Re: 40B Applications: 41 North Main Street and 31 Hunting Lane ("Pine Residences" & "Apple Hill Estates")

At the request of the Hunting Lane Neighbors Group, Creative Land and Water Engineering, LLC conducted a review of the referenced projects. We have focused on the water related issues. We have the following comments:

## Summary of the Project sites and vicinity watershed

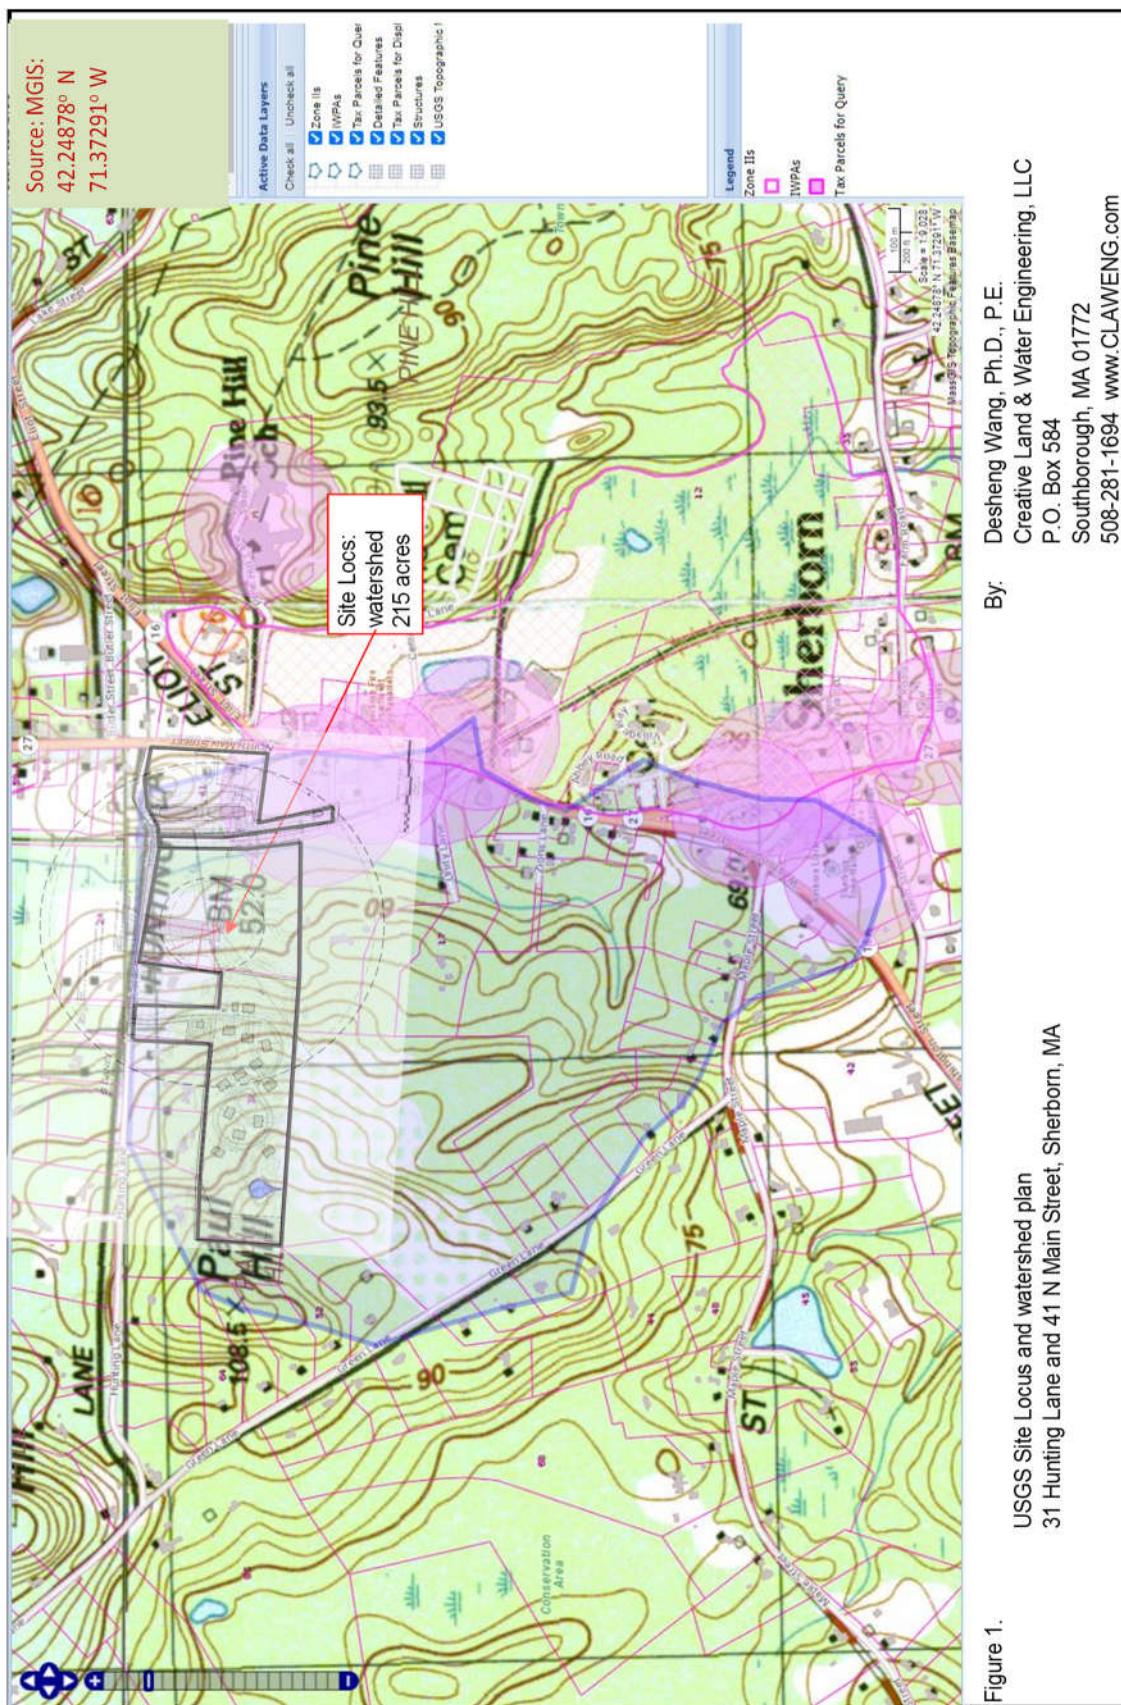
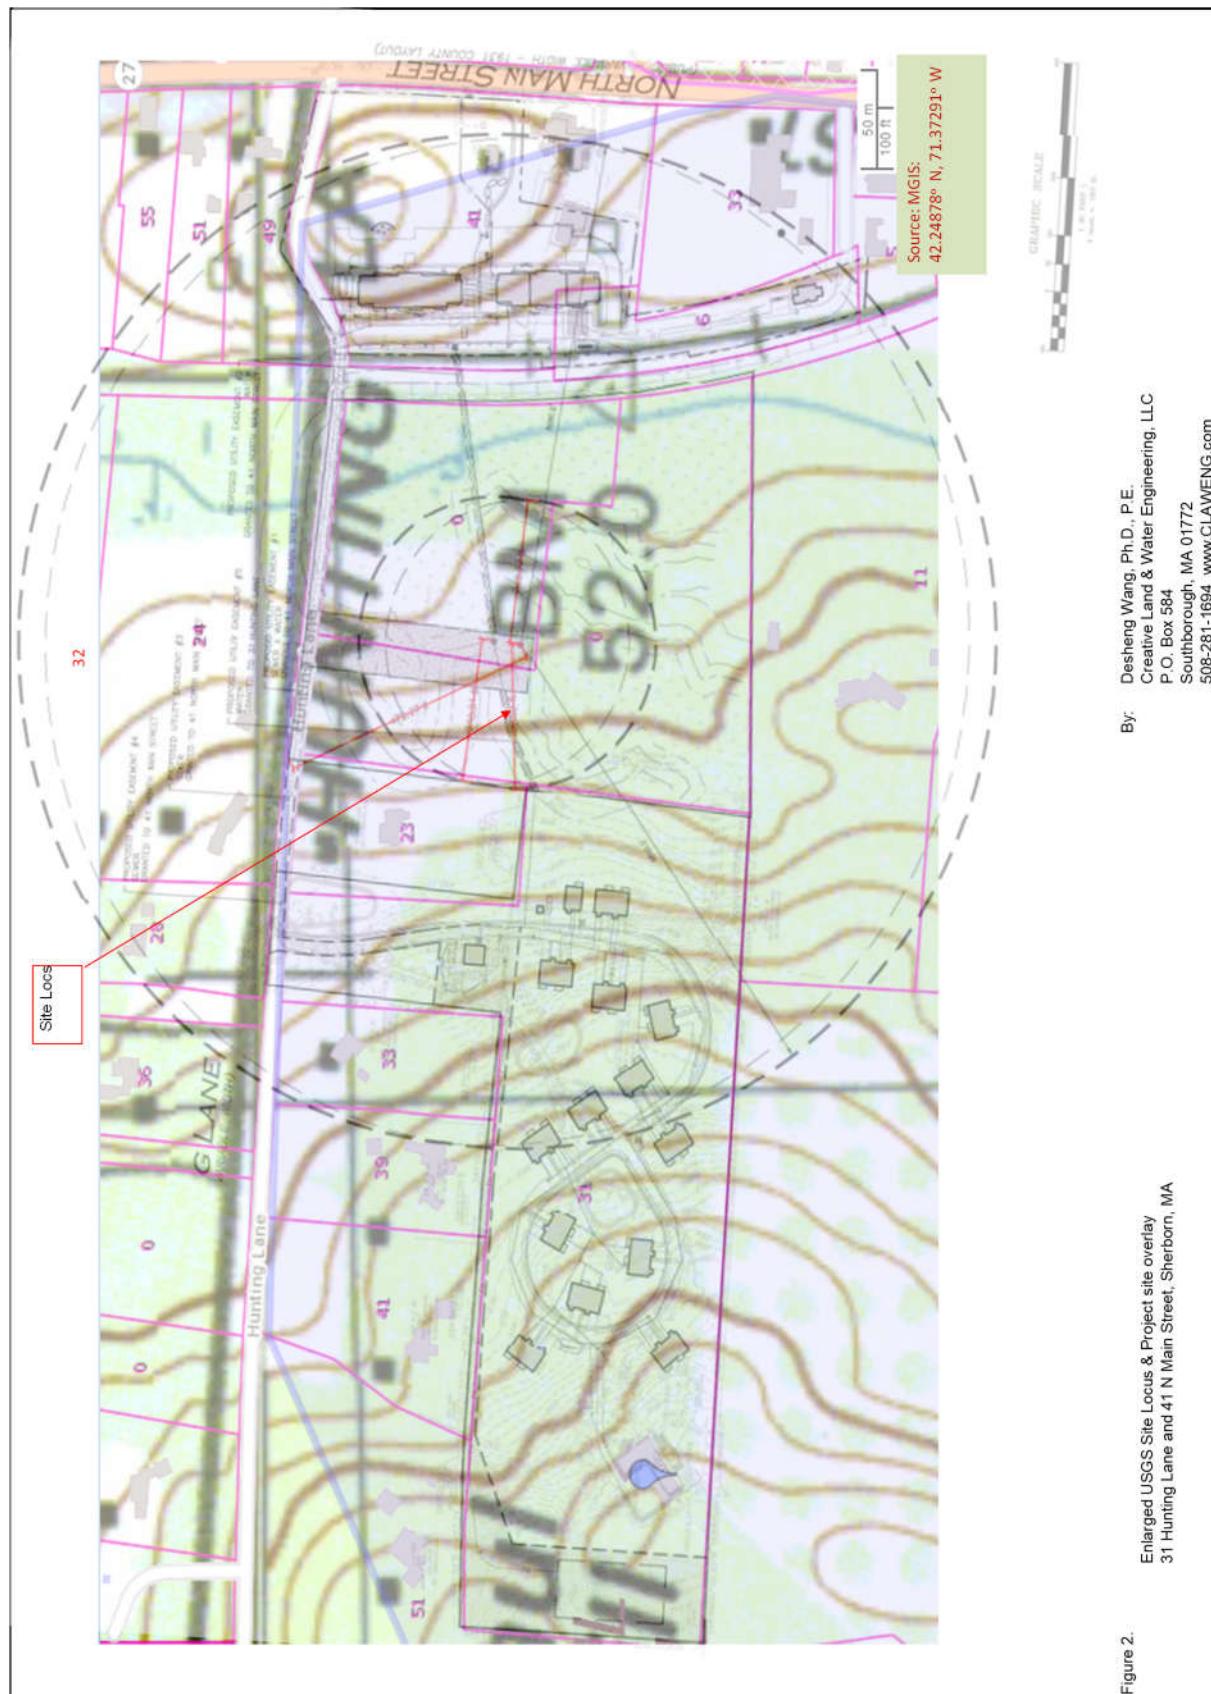
The project site is located on a total of 36.06 acres of land including 8 acres of land dedicated to water supply wells. The land is located in the watershed to an intermittent stream, namely Indian Brook, which becomes a perennial river further downstream. The applicable watershed contains mostly tight glacial till and hollis-rock-outcrop. Well drained high permeable soil area is less than 8% of the watershed. See Figure 3 for soil distribution in the watershed. The project site counts for about 17% of the total watershed. See Figures 1 and 2 for watershed area with overlay of the project site.

Total	Land area:	36.06 acres	17% total wshd
	Total home units:	88 units	
	Total bedrooms:	192 brms	384 people
	Title 5 support flow (W+S)	4319.63 gpd	
	Design flow	21120 gpd	7708800 gpy
			4.89 times of allowed

Well	2 on Parcel 8 ac 11-0-3B
Zone I	250 ft
IWHP	880 ft
To wetland	42 ft, approx.
To 23 Hunting	250 ft

Figure 3.  
 NRCS Soil Map  
 31 Hunting Lane and 41 N Main Street,  
 Sherborn, MA

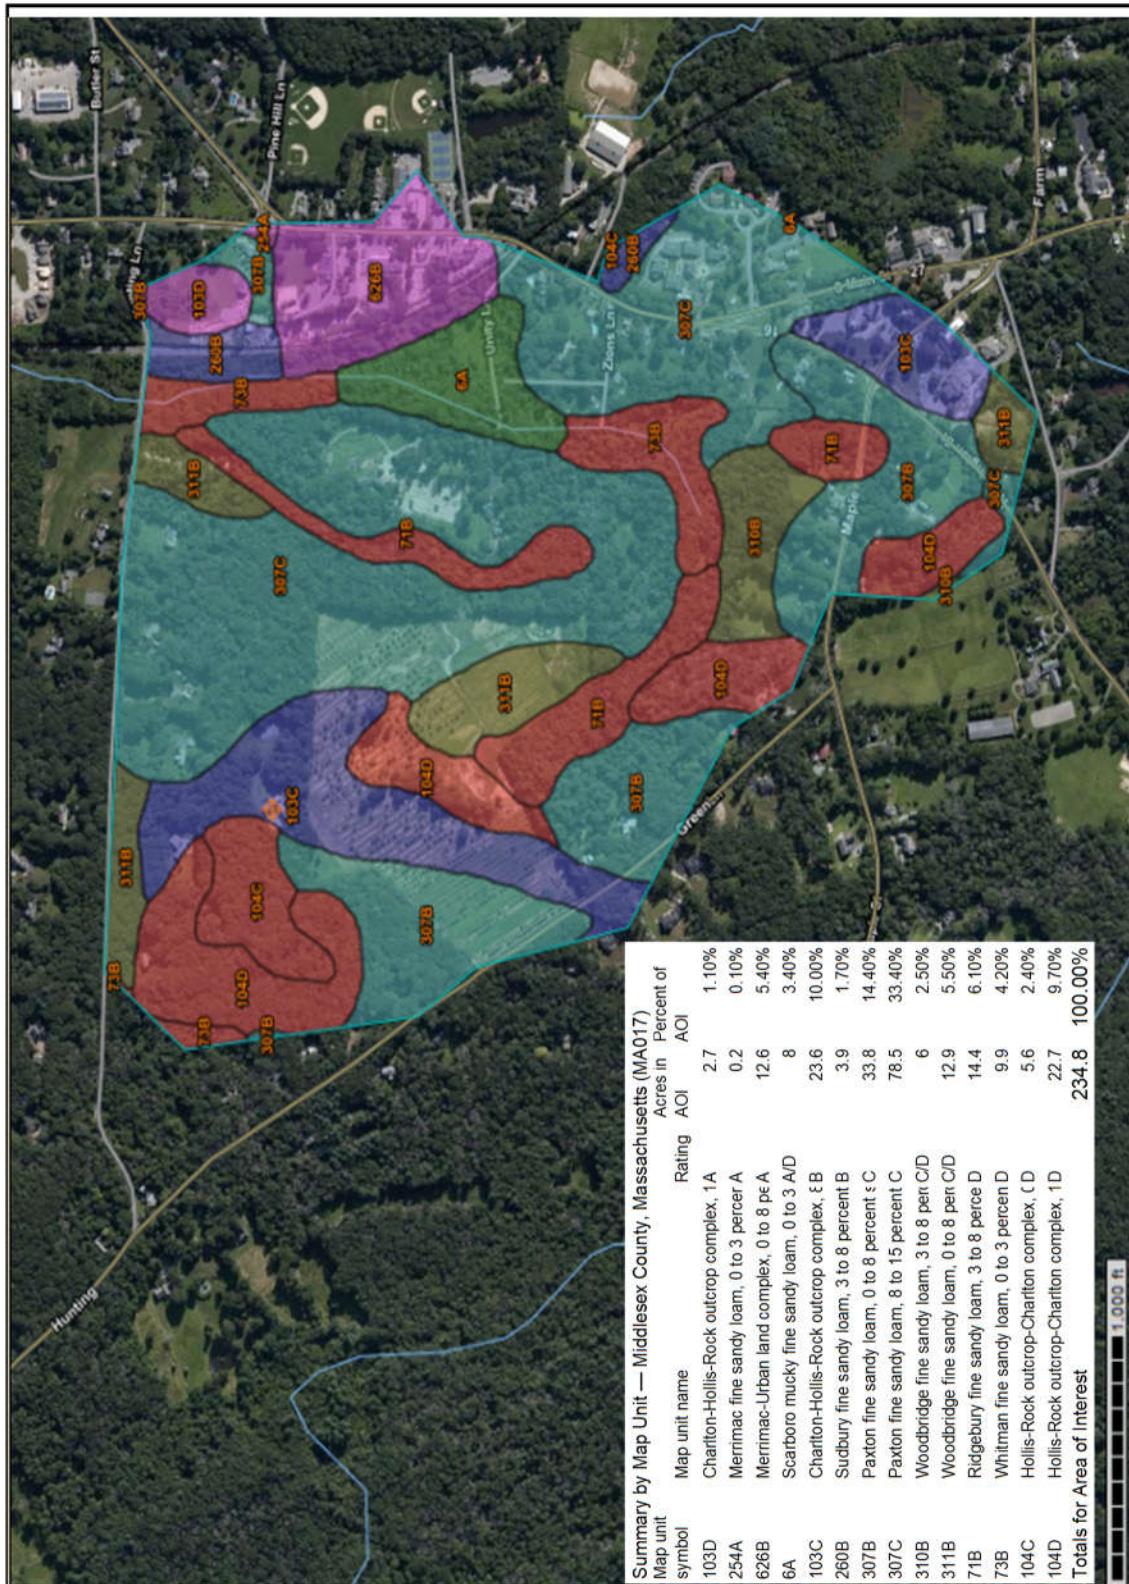
Bedrock	Mafic rock	Silurian and ordovician volcanic and granitic rocks
Aquifer	very low yield	
	Soils:
